THM 4T65-E UPDATE HANDBOOK

INTRODUCTION THM 4T65-E UPDATE HANDBOOK

Figure 70

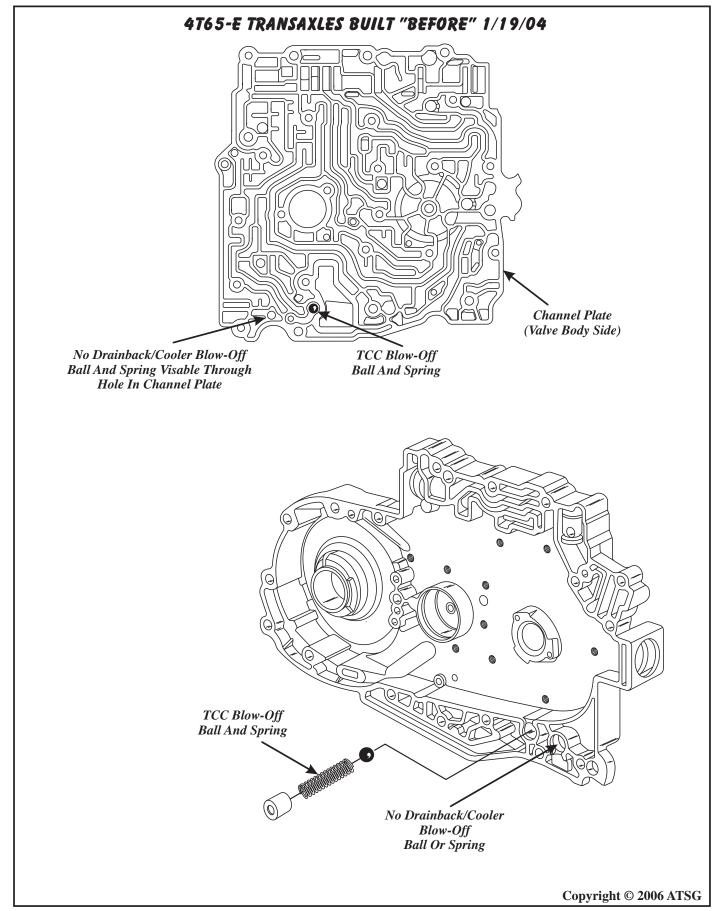
- (1) CHANNEL PLATE Drainback ball, spring, and retainer added to the channel plate next to the torque converter blow-off ball and spring. Channel Plates built "Before" January 19, 2004 are shown in Figure 70, and the Channel Plates built "After" January 19, 2004 are shown in Figure 71.
- (2) RETURN COOLER FITTING The January 19, 2004 and later cooler line case fittings both have the same threads, which is 9/16-18 UNF, and the return line cooler case fitting does not contain a ball and spring. Refer to Figure 72.

Figure 71

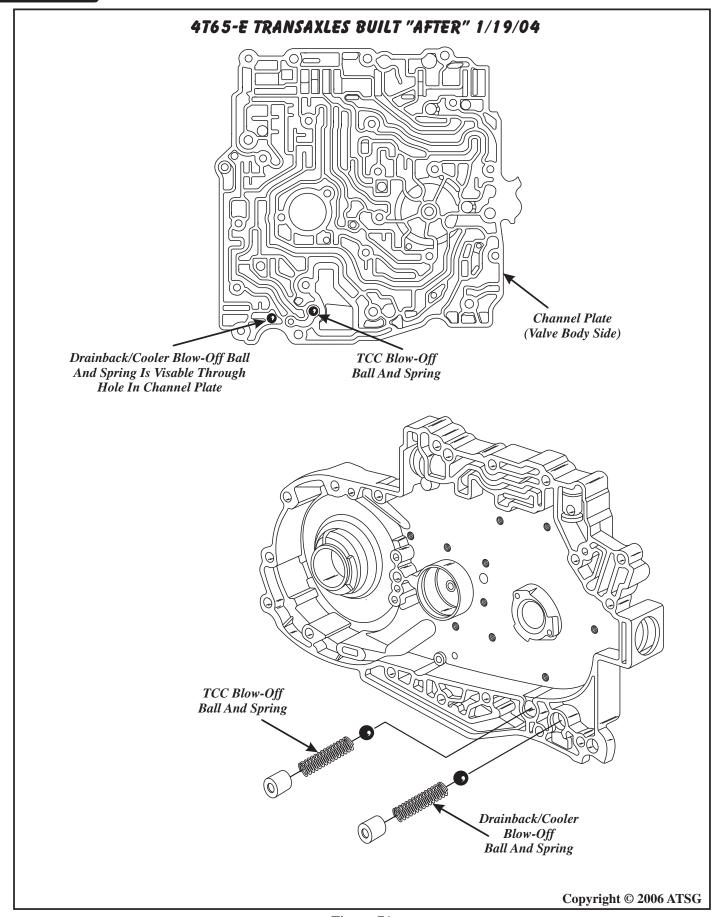
CHANGE: Beginning on January 19, 2004, all 4T65-E transaxles were built with the drainback ball removed from the return cooler line fitting, and relocated in the channel plate next to the torque converter blow-off ball and spring. Refer to Figure 71.

Figure 72

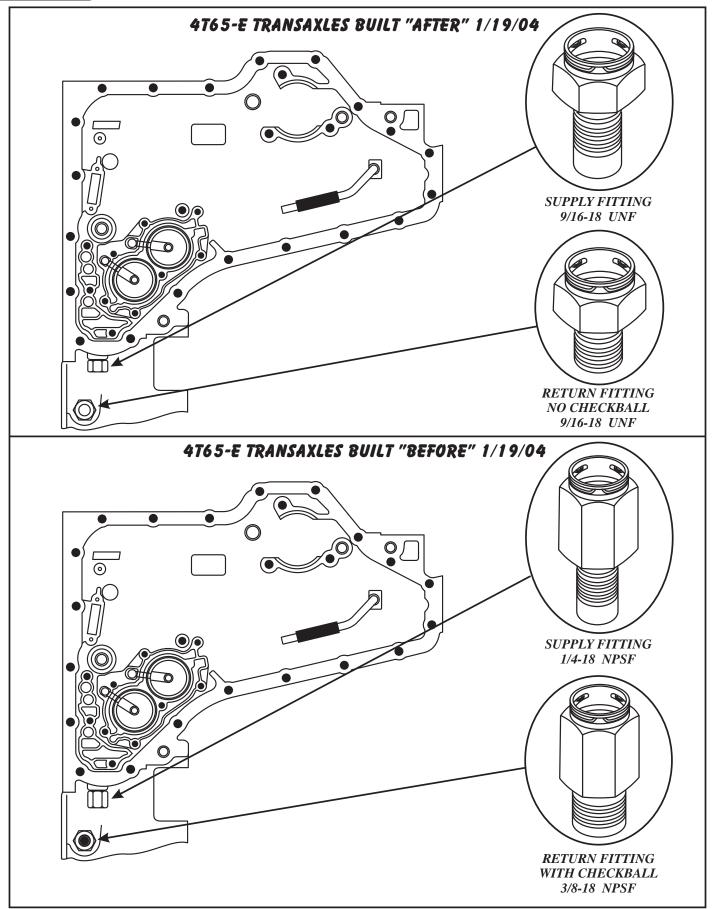
The prior to January 19, 2004 cooler line case fittings have different threads. The supply cooler line case fitting has a 1/4-18 NPSF thread. The return line cooler case fitting has a 3/8-18 NPSF thread, and contains the drainback ball and spring. Refer to Figure 72.

When Channel Plate replacement is required, make certain that the 'Drainback/Cooler Blow-Off ball and spring is present, and in the proper location for the model year transaxle you are rebuilding.
